MONTGOMERY COUNTY HISTORIC PRESERVATION COMMISSION
STAFF REPORT

Address:	3947 Baltimore St., Kensington	Meeting Date:	6/28/2023
Resource:	Primary One Resource Kensington Historic District	Report Date:	6/21/2023
Applicant:	Franco Construction, LLC	Public Notice:	6/14/2023
Review:	HAWP	Staff:	Dan Bruechert
Case No:	1032242	Tax Credit:	n/a
PROPOSAL:	Fenestration Alteration

Figure 2: 2018 approved HAWP to change the rear fenestration and install a deck.

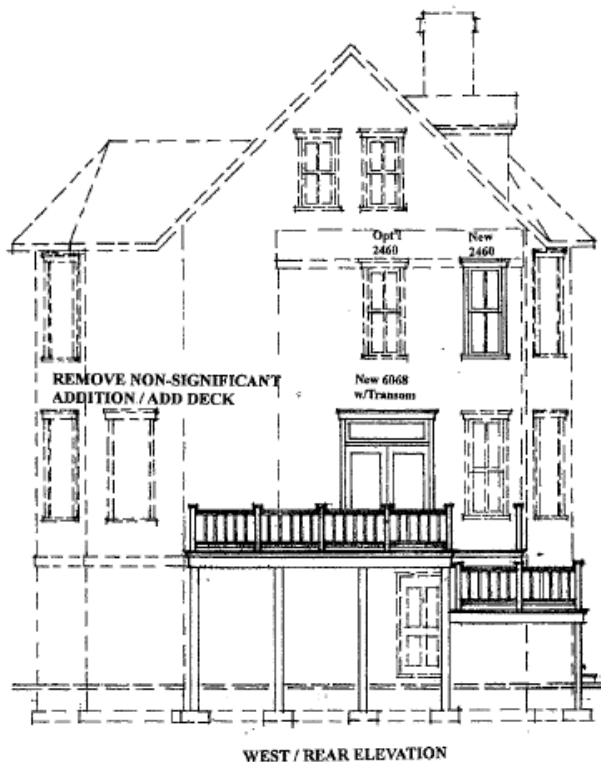
The subject property is a clapboard sided-house with a front gable roof and Queen Anne and Colonial Revival elements. In 2018, the HPC approved a HAWP to demolish the sleeping porch at the rear, construct a deck, and alter the rear fenestration. The porch was removed, but the fenestration was not changed. The 2018 HAWP has not been digitized, however, the approved rear elevation is shown in Figure 2, below. The applicant proposes to alter two openings on the rear elevation of the subject property.

REAR ELEVATION

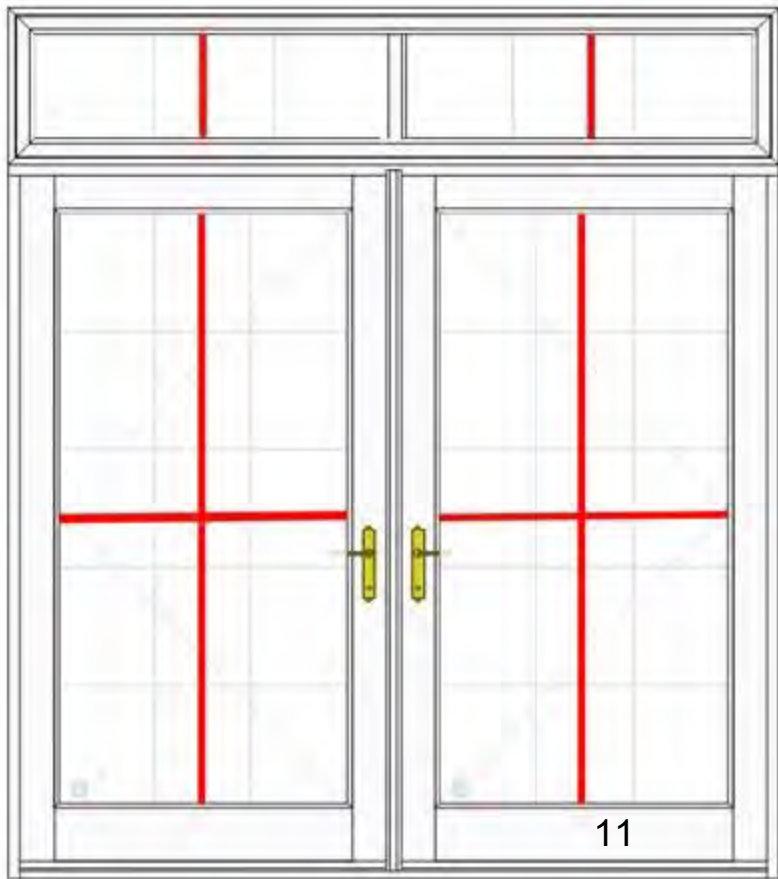
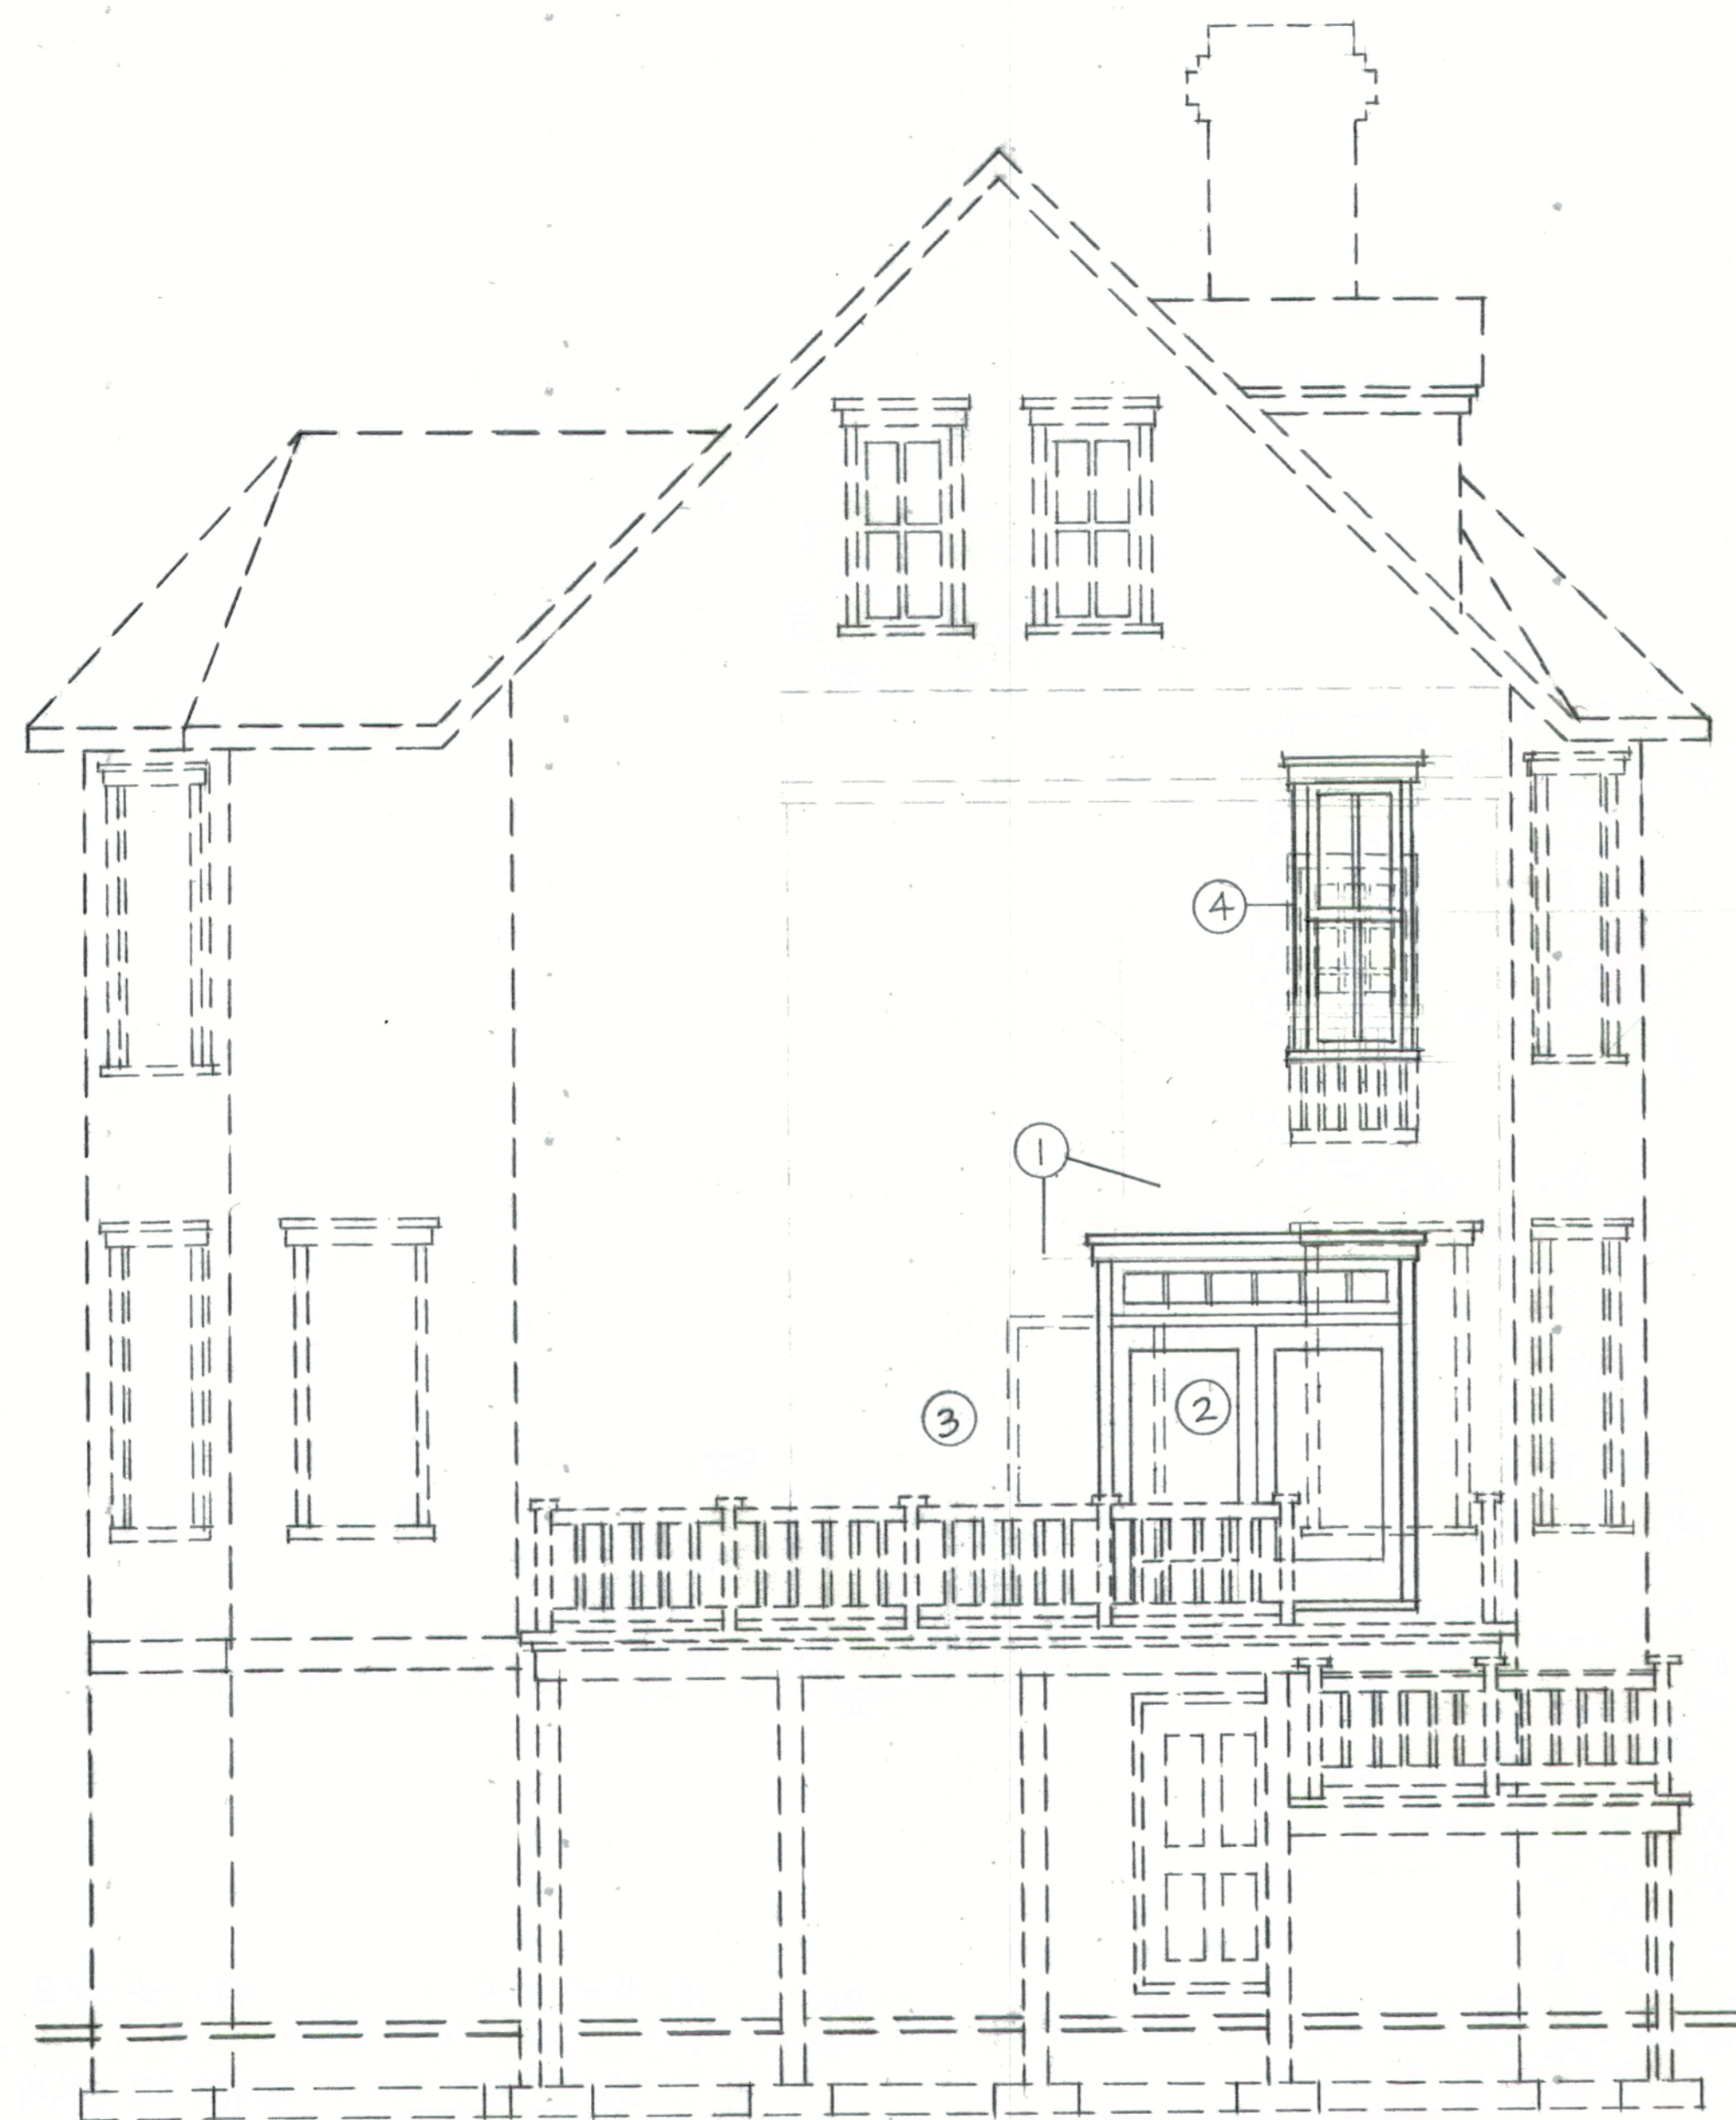
On the ground floor, the applicant proposes to remove a second-story door and a door and a window on the first floor. In place of the second-story window, the applicant proposes to install a wood two-over-two SDL sash window. On the first floor, the applicant proposes to install a pair of four-light Lincoln

aluminum clad doors with a two-light transom above each door. The second-story door historically provided access to the sleeping porch – removed as part of the 2018 HAWP, discussed above. All proposed siding and trim will match the existing in materials, dimensions, and appearance. The siding will be patched to match the existing wood clapboards.

Staff finds the proposed changes will not have a significant impact on the character of the house or surrounding district, per 24A-8(b)(1). While the openings appear to be historic, removing the sleeping porch and constructing the existing deck (also approved in 2018) have changed the house's appearance and how the rear of the house is used. Additionally, Staff finds changes to the rear of properties in historic districts are generally given more lenience because they are not visible from the right of way and do not tend to impact the overall character of the district (see 24A-8(d)).

Staff finds the proposed wood window is an appropriate material for alterations to the openings at the rear of the house (24A-8(b)(2)). Additionally, Staff notes the proposed window will match the two-over-two windows found throughout the house. The one detail missing in the material specification is the treatment of the grille on the two-over-two window. The HPC's typical requirement is for SDL windows to have permanently affixed exterior and interior grilles with a spacer bar between the glass. These features create an appearance closest to a traditionally constructed simulated divided light window. Lincoln Windows offers windows in that configuration, but also offers windows without the interior spacer bar. Staff recommends the HPC add a condition that the proposed window needs to have an interior spacer bar and delegate final approval authority to Staff to verify the condition has been satisfied.

Staff finds the proposed aluminum-clad wood door is appropriate for a new opening on the rear elevation of the subject house (24A-8(b)(2) and (d)). Staff additionally finds the proposed four-light configuration is appropriate, but would also recommend the HPC approve a pair of single-light doors, per 24A-8(d).

The owner wishes to change the lite pattern on the french door to better match the windows. They would also like to have both the door and window units to be manufactured from Lincoln since the preferred 7' wide door sizing is unavailable from Andersen. Also, Lincoln will not warranty the door in wood but they will warranty the door in clad which is herein requested. The new rear window unit shall remain wood. All other specifications remain the same.

Staff recommends the HPC **approve** the HAWP application **with one (1) condition:**

1. The proposed window shall have exterior and interior grilles and a spacer bar between the panes of glass. Specifications showing this condition has been satisfied shall be submitted to Staff for final approval.
